## ALERT SERVICE BULLETIN

TRANSMITTAL LETTER  
FOR  
ALERT SERVICE BULLETIN ANMD-27-44

FLIGHT CONTROLS — FLAPS —  
COMPONENTS SAFE LIVES

## ANMD-27-44

Figure 1 Flap Control Components, General Locations

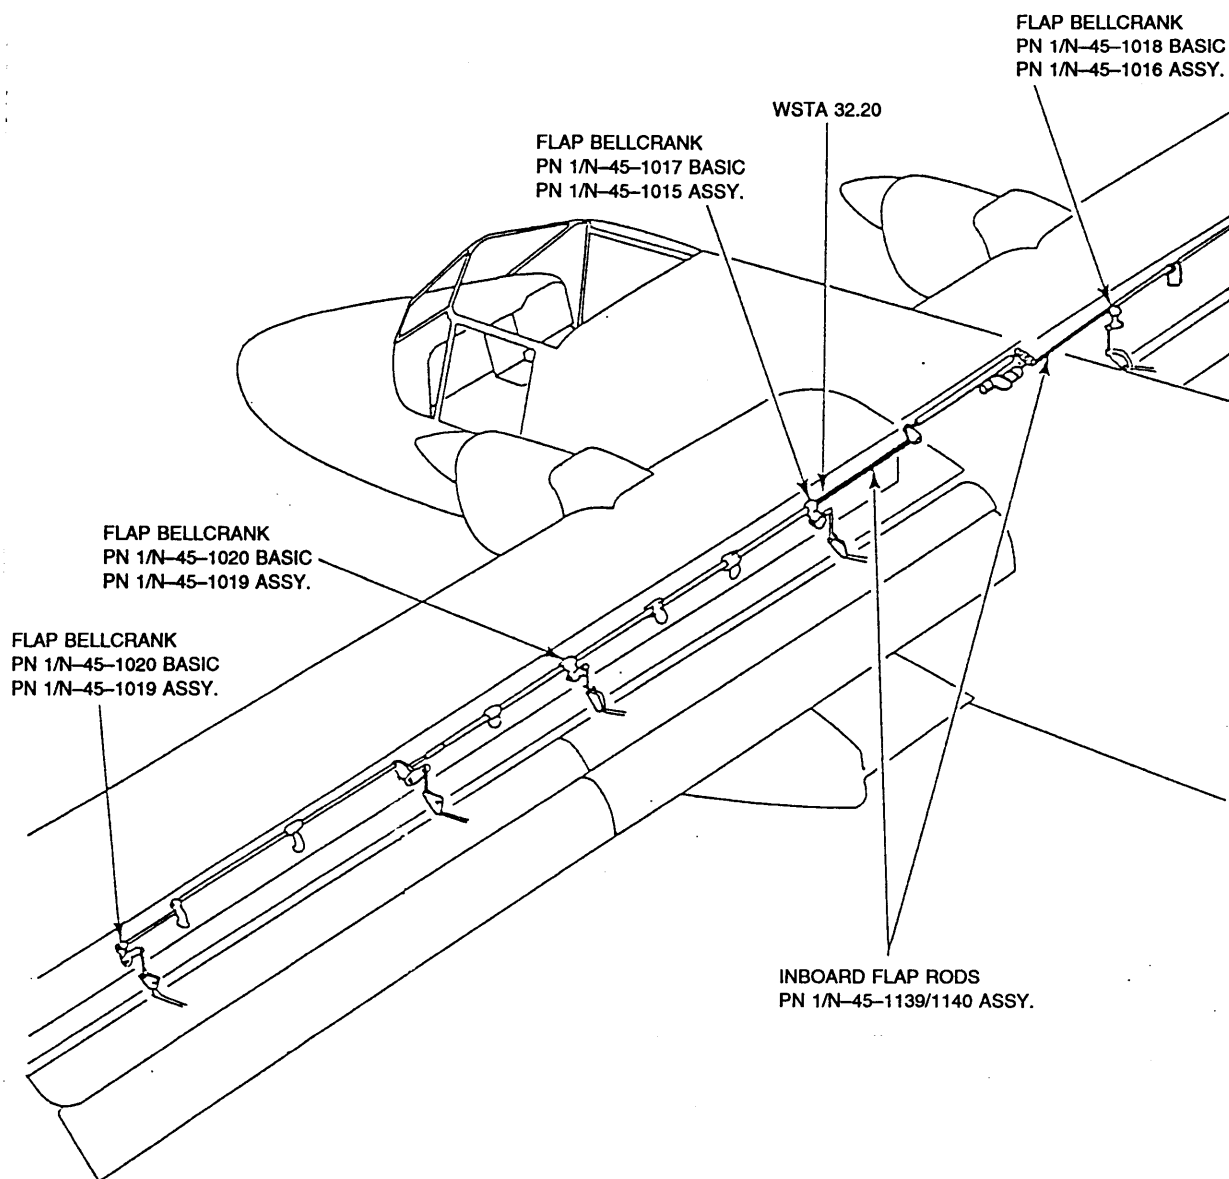
The following flap control components are to be immediately replaced with new items.

- (2) Make sure aircraft electrical power is switched OFF and the flap circuit breakers are tripped.
- (3) Gain access to flap control rods PN 1/N-45-1139/1140, flap control bellcranks PN 1/N-45-1017/1018 and bellcranks PN 1/N-45-1020/1019 (Ref fig 1) by removing necessary access panels (Ref MM Chap 27-50-08).
- (4) Support the flap control surfaces.
- (5) As required, remove the existing flap control rods PN 1/N-45-1139/1140, bellcranks PN 1/N-45-1017/1018 and PN 1/N-45-1020/1019 (Ref fig 1) and replace with new items.
- (6) Remove the flap control surface supports.
- (7) Check the flap control system rigging (Ref MM Chap 27-50-00).

Figure 2 Possible Cracking on Flap Bellcrank and Flap Rod End Fittings

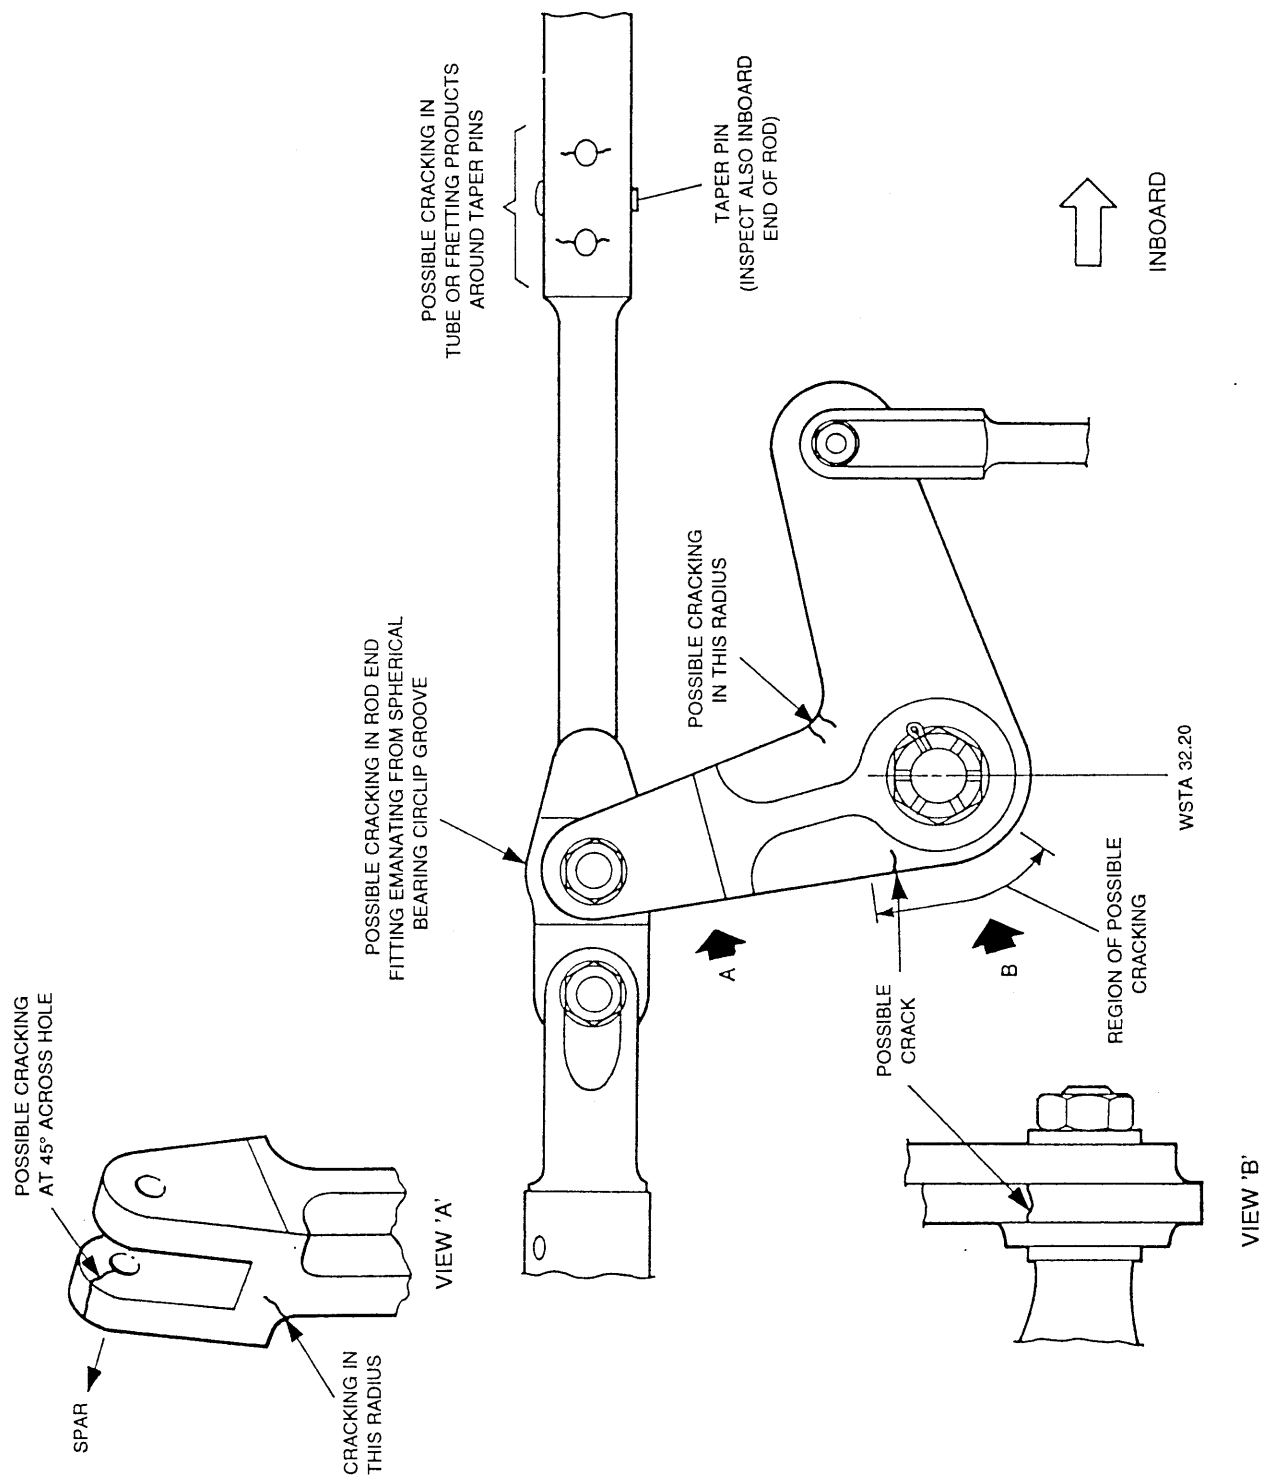
- (a) Visually inspect the inboard flap control rods PN 1/N-45-1139/1140 for cracking, fretting or corrosion and general condition, especially at the end fitting and taper pin areas (Ref Fig 2). A mirror will be required to view backside of the rods.

- Fatigue related damage (cracking, fretting etc) is likely to be in proportion to the loading seen by the rod therefore these inboard rods are more likely to have such damage than the outer rods, since their loading is higher.
  - Pay particular attention to the inspection of the end fitting attachment at wsta 32.20 (Ref Fig 2).
- (b) If pin or end fitting looseness or fretting is detected or cracking is suspected, the flap control rod is to be removed before further flight (Ref MM Chap 27-50-08) and an NDI inspection carried out using the dye penetrant or similar method.
- (c) If cracking is confirmed the item is to be renewed before further flight.

- (a) Visually inspect each of the bellcranks PN 1/N-45-1019/1020 (4 off) and PN 1/N-45-1017/1018 (Ref Fig 1) for possible cracking, corrosion and general condition (Ref Fig 2).
- (b) If cracking is detected or suspected, the bellcrank is to be removed before further flight (Ref MM Chap 27-50-00) and an NDI inspection carried out using the dye penetrant or similar method.
- (c) If cracking is confirmed, the item is to be renewed before further flight.
